**ADDENDUM NO. 5
TO
CONTRACT DOCUMENTS, SPECIFICATIONS AND PLANS
FOR IMPROVEMENTS TO THE
ST. JOSEPH ROSECRANS MEMORIAL AIRPORT
ST. JOSEPH, MISSOURI
MODOT PROJECT NO. 22-012A-1**

To All Bidders: You are requested to make all changes and/or additions contained in this addendum to the Bidding Documents. Failure to acknowledge this Addendum in Proposal shall result in rejection of bid. Bidders are informed that the above referenced Questions with Corresponding Answers, Contract Documents, Specifications, and Plans are modified as follows as of December 7, 2022.

SITE UTILITY DEMOLITION PLAN

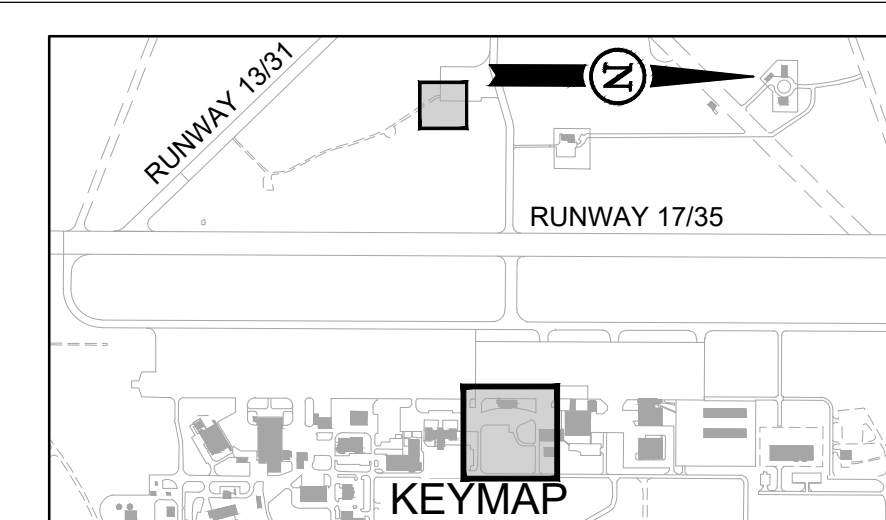
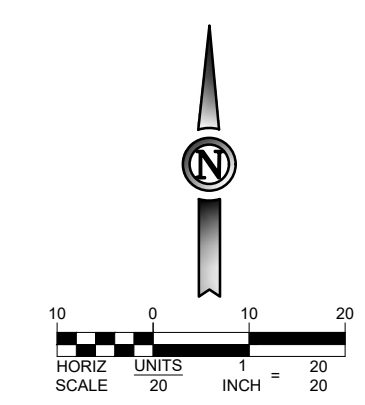
Sheet CD-101 Site Utility Demolition Plan

Revision: Removed Phase 2 Demolition from CD-101.

5. On the plan sheet CD101 there is a note to remove three existing vault / manholes in one area and one more just to the north that house communications and airfield lighting. Sheet E300 (Inlay-3) has a note to install conduits and fiber cabling between the same three existing manholes. Do these three vaults stay in place, remove, or get replaced with new vaults? One of the electrical vaults appears to be modern, the other three appear to be much older or of the composite type.
 - a) These manholes are not to be removed. A revised version of sheet CD-101 is included in this addendum.

OVERALL FIRST FLOOR ARCHITECTURAL PLAN

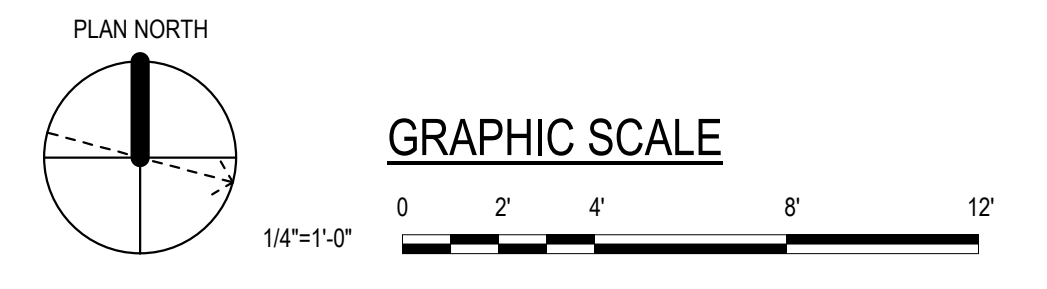
Sheet A-101, A-102, A-202, A-301, A-315, A-711, A-712

Revision: Removed glass half wall along outside patio.

4. With the tempered laminated glass half wall along the outside patio being set into a reglet in the stone, could moisture accumulation at the base of the glass eventually degrade the PVB inner layer causing an appearance problem?
 - a) The half glass partition along the patio wall has been removed entirely. This can be seen in revised plans A-101, A-102, A-202, A-301, A-315, A-711, and A-712
